**BSR/ASHRAE Addendum cv to  
ANSI/ASHRAE Standard 135-2024**

**Proposed Addendum cv to Standard  
135-2024, BACnet<sup>®</sup> - A Data  
Communication Protocol for Building  
Automation and Control Networks**

**First Publication Public Review (February 2026)  
(Draft shows Proposed Changes to Current Standard)**

### **135-2024*cv*-1 BACnet Data Link Protocol Bridge, p. 3**

Figure H.Y.1: MS/TP Bridge Segments – Wireless

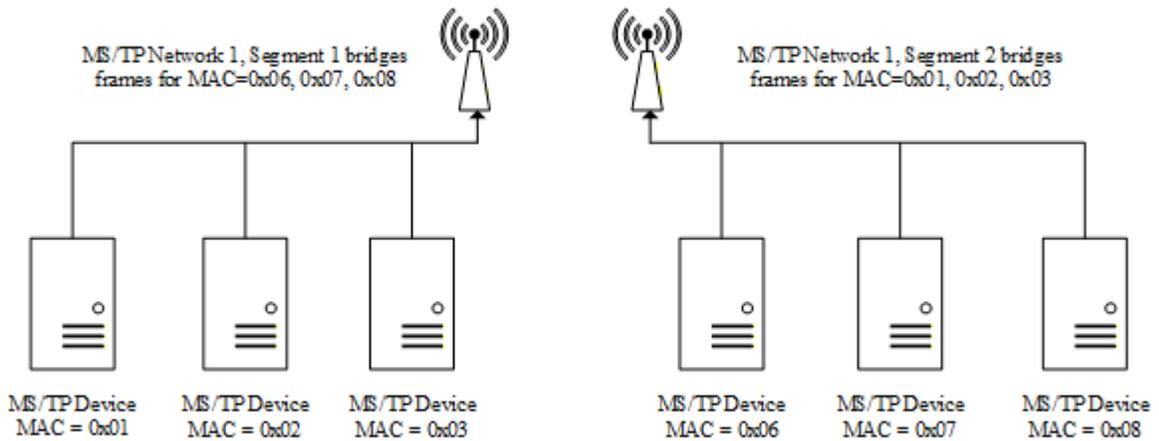
In contrast to BACnet MS/TP repeaters, defined in Clause 9.9, where all segments use the same bit rate, BACnet MS/TP bridges may be used to connect MS/TP network segments that may have different bit rates.

The following rules for handling MS/TP frames shall be used at each bridge.

- Each bridge shall provide local MS/TP network synchronization using Token, Poll For Manager, and Reply To Poll For Manager frame types, according to Clause 9.5.6, for every MS/TP bridged node, and these frames shall not be forwarded to bridged segments.

- For MS/TP Manager node destinations, upon receipt of either a BACnet Data Expecting Reply or BACnet Extended Data Expecting Reply frame, the bridge shall transmit a Reply Postponed frame to the originating bridged node before forwarding the frame. This allows the bridged node to leave the ANSWER\_DATA\_REQUEST state and the sending node to leave the WAIT\_FOR\_REPLY state before the potentially lengthy process of forwarding has begun.

- Reply Postponed frames shall not be forwarded.
- For MS/TP Manager node destinations, upon receipt of a Test\_Request frame, the bridge shall transmit a Test\_Response frame, according to Clause 9.1.3 and Clause 9.3.5, and these frames shall not be forwarded.

- All other MS/TP frames shall be forwarded.
- Subordinate nodes are not required to be supported.
